ENGINEERING CHANGE NOTICE						
		Date	e: Do	ocument Number			
Originator:	Bo Byoung Jeon	July 13,	2023 EG	CN20230713-00			
Phone No.	(416) 754-3322	Suly 10,					
Email Address:	<u>bbjeon@edac.net</u>	Part Nu	mber D	rawing Revision			
Department	ENGINEERING	690-009-236C900, (690-009-636C900	Rev.6			
CHANGE TYPE							
CLASS I	CLASS I Customer notification and approval required prior to implementation						
X CLASS II	X CLASS II Customer notification only, no approval required						
CLASS III No customer notification required							
REASON OF CHANGE							
Adding Part Number 690-009-	236C900 which has Gold-Flash Plating						
DESCRIPTION OF CHANGE:	1200						
The following table has been a	added in the drawing	-					
	69	0-009- <u>63</u> 6C900					
		PLATING					
1	PART NUMBE	R PLATING					
	690-009-236C9	000 GOLD-FLASH PLATING					
	690-009-636C9	30u" GOLD PLATING					
Effective implementation to	distribution is on July 13, 2023

USB 3.0 TYPE A FEMALE, SIDE, RIGHT ANGLE, THROUGH HOLE

DRAWING NUMBER: 690-009-636C900 **ISSUE** 6 SEE TABLE PART NUMBER:

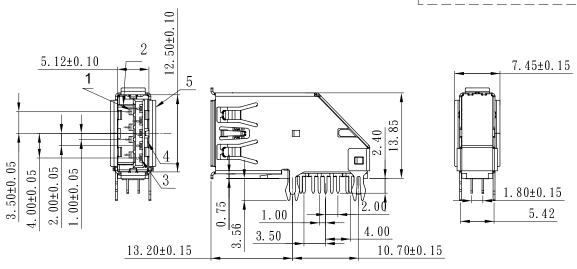
PLATING
PART NUMBER	PLATING
690-009-236C900	GOLD-FLASH PLATING
690-009-6360900	30u" GOLD PLATING
